**CERTIFICATE OF APPROPRIATENESS**

**Property:** 642 Columbia Street, Lot 23, Block 281, Houston Heights Subdivision. The property includes a noncontributing 2,086 square foot, one-story wood frame brick clad single family residence and one-story detached garage situated on a 6,600 square foot (50' x 132') interior lot.

**Proposal:** New Construction – Revision. Remove front gable on porch roof, remove gable on front elevation of the garage, reduce the width of the garage by approximately 3'; connect the garage to the residence with a covered breezeway.

**WEST (REAR) ELEVATION**  
APPROVED (FEBRUARY 26, 2015)

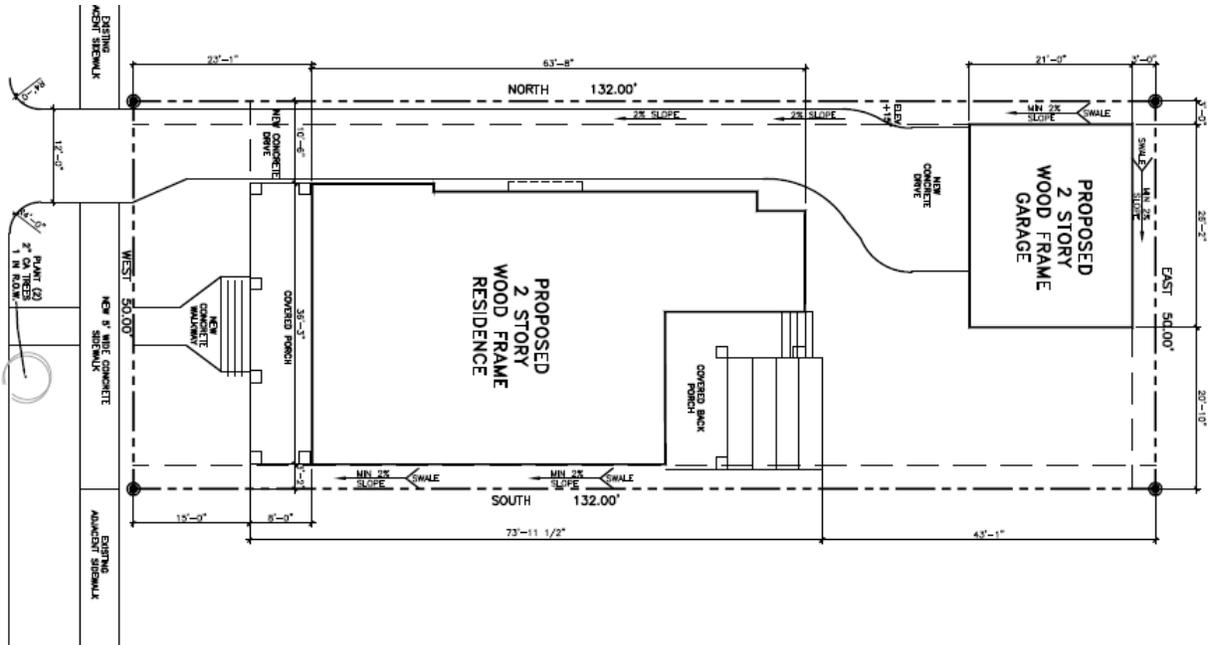
- Rear Elevation:** 12-17-2014: The rear elevation of the residence will not visible from the public Right-of-Way.
- (East)** 01-29-2015: The proposed revisions to the rear elevation of the residence will not visible from the public Right-of-Way.
- 02-26-2015: The proposed revisions to the rear elevation of the residence will not visible from the public Right-of-Way.
- 06-18-2015: The proposed revisions to the rear elevation of the residence will not visible from the public Right-of-Way. See drawings for more detail.

SITE PLAN

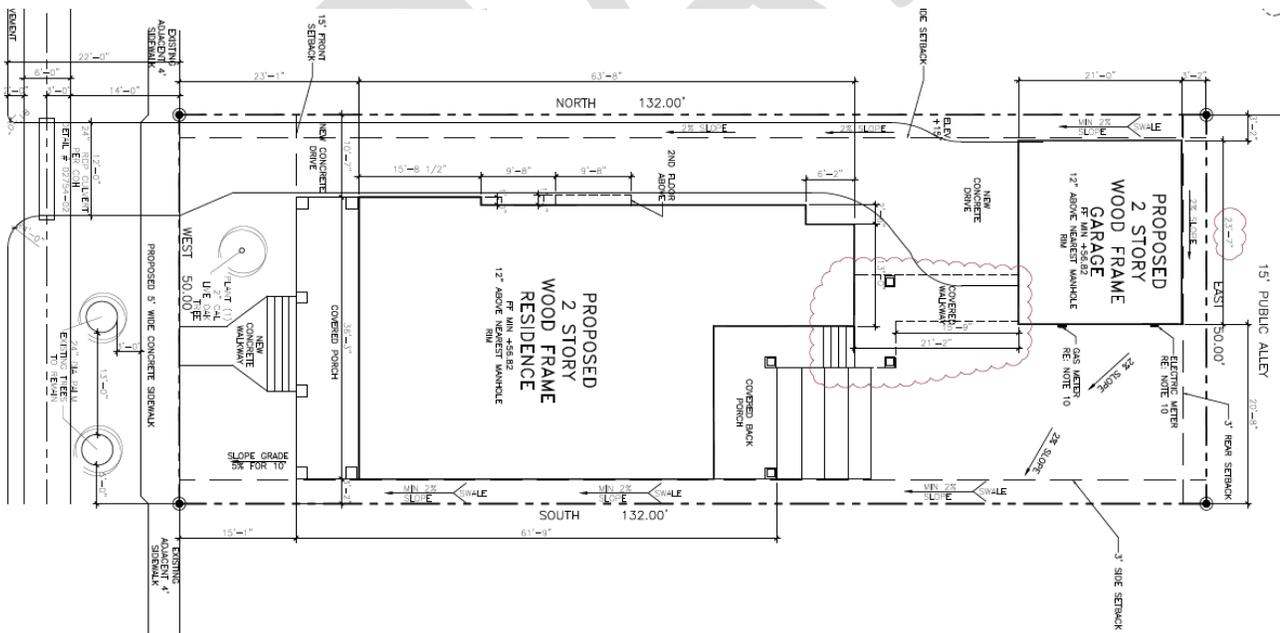
06-18-2015: In the revised proposal, the garage width will be reduced from 26'-2" to 23'-7". The shape and mass of the main residence will not be altered. However, the proposed garage will now be connected to the main residence by a 21'-2" long covered breezeway. See drawings for more detail.

06-18-2015: In the revised proposal, the residence will have a north setback 10'-7" and the garage will have a north side setback of 3'-2"; a south side setback of 20'-8"; and a rear (east) setback of 3'-2". See drawings for more detail.

### ROOF PLAN

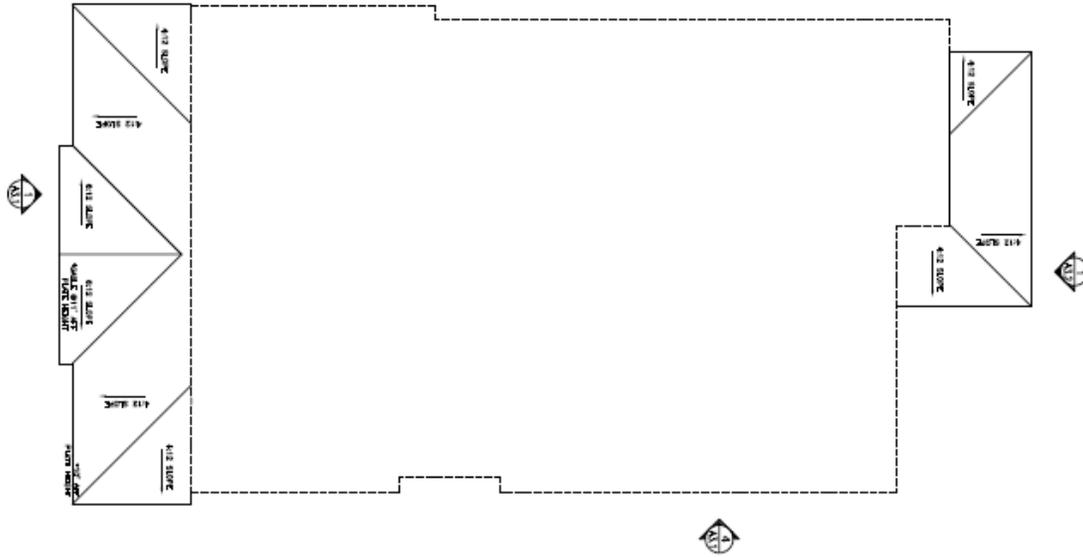
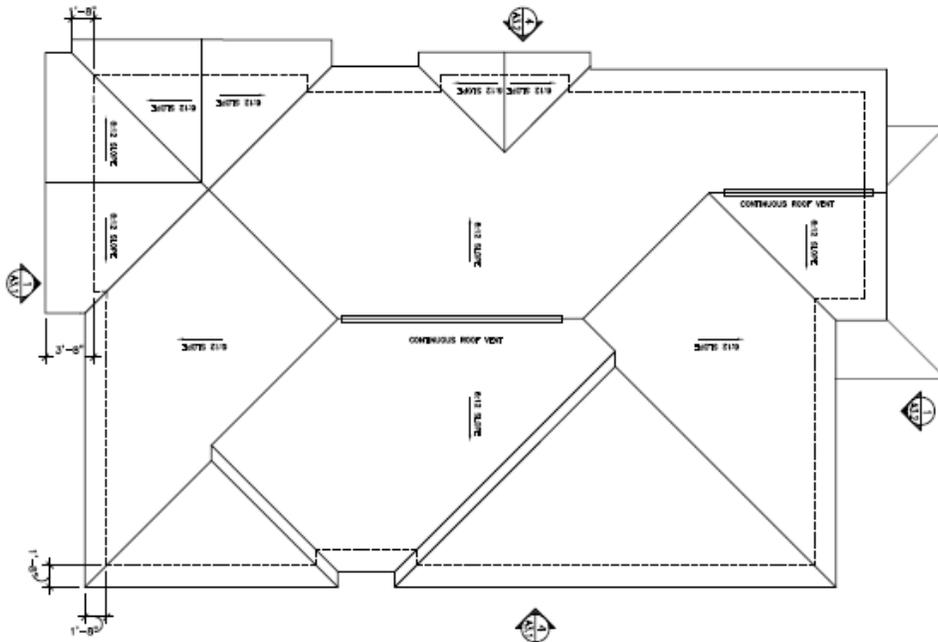
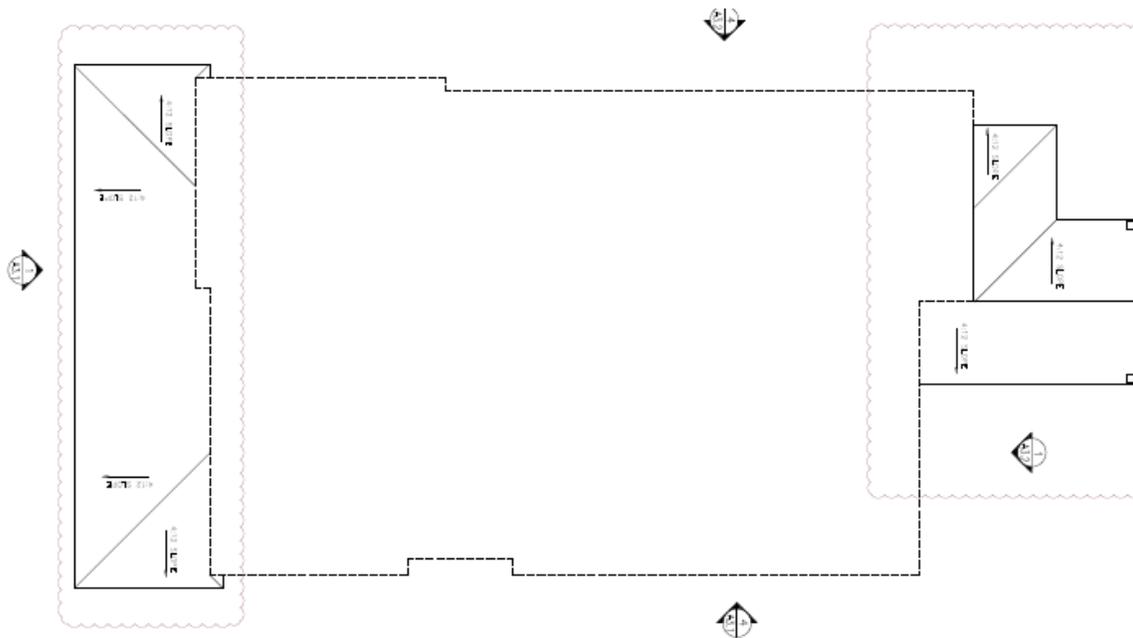
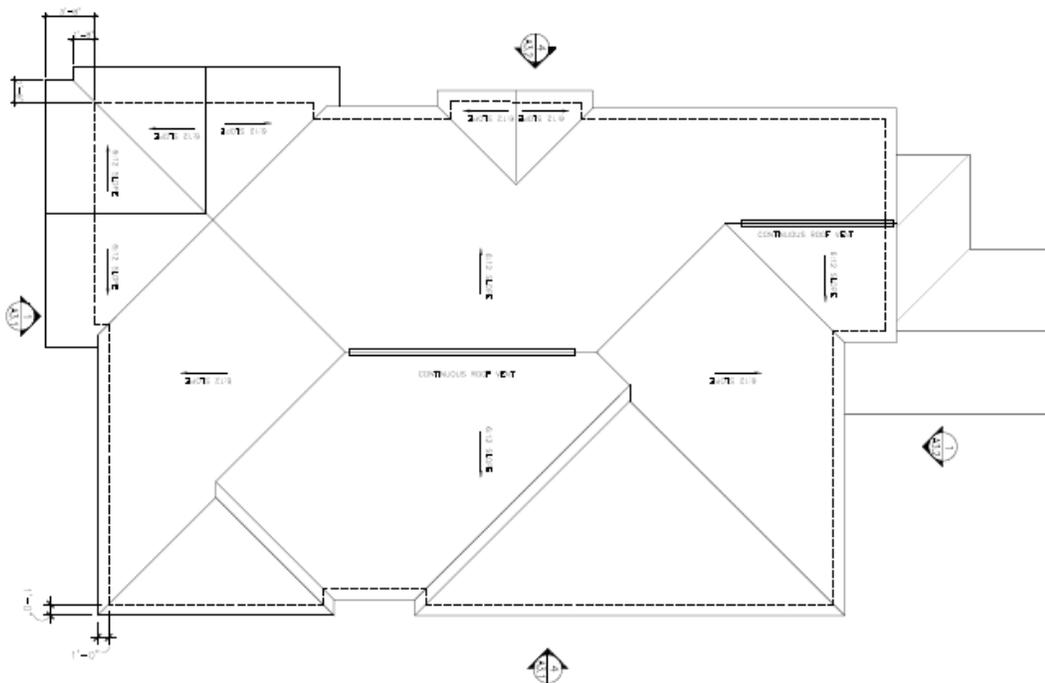
06-18-2015: In the revised proposal, the front gable on the porch roof will be removed. The gable on the west (front) elevation of the garage will be removed. Both roof will now be hipped without any gables. The proposed composition shingle roof will now be standing seam metal. The See drawings for more detail.

**GARAGE ELEVATIONS**

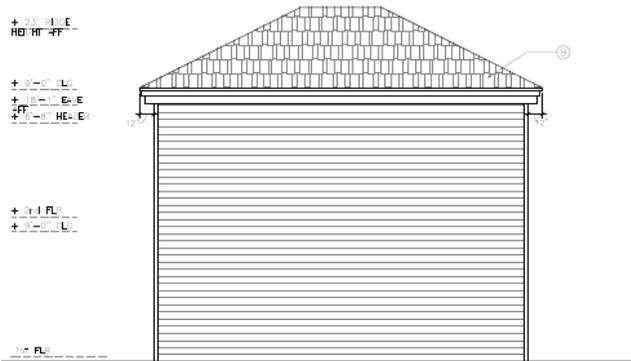
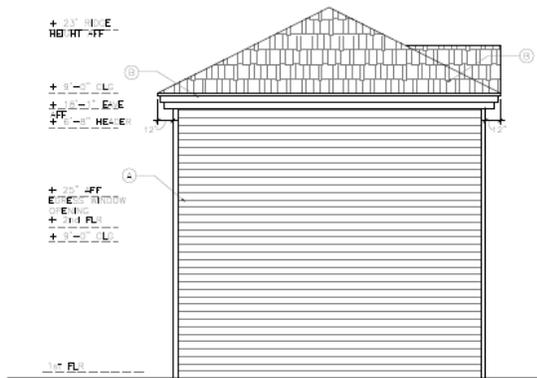
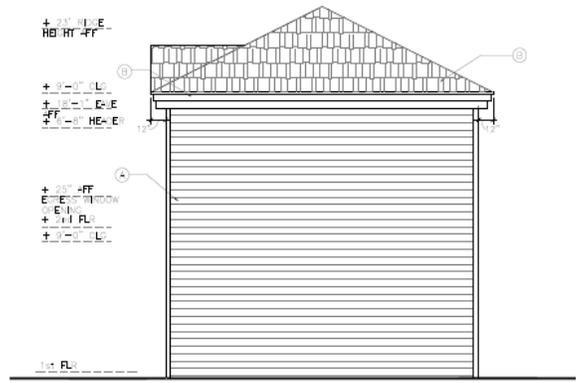
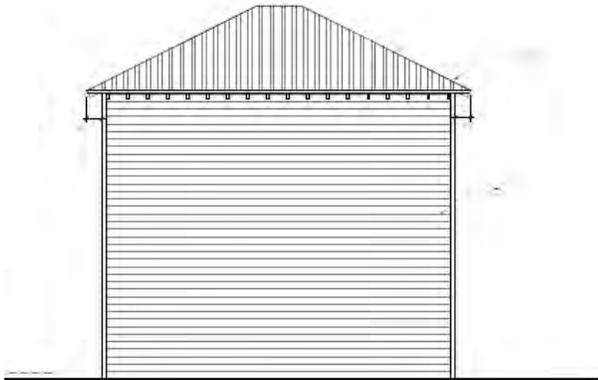
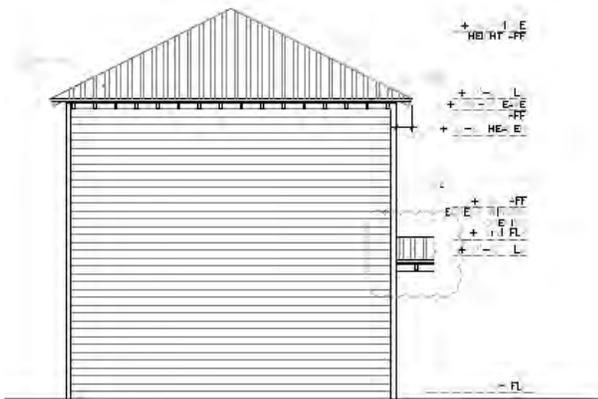
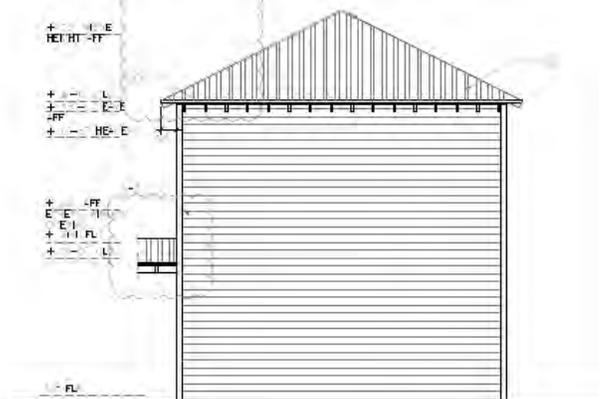
06-18-2015: An additional 1-over-1 double-hung wood window will be added to the west (front) elevation of the garage. The remaining fenestration will remain unchanged. See drawings and windows schedule for more detail.

06-18-2015: The centrally located front gable on the front porch roof will be removed; the porch roof will now be hipped. On the garage, the front facing gable on the front elevation will also be removed and a third window will be added to the second-story. See drawings for more detail.
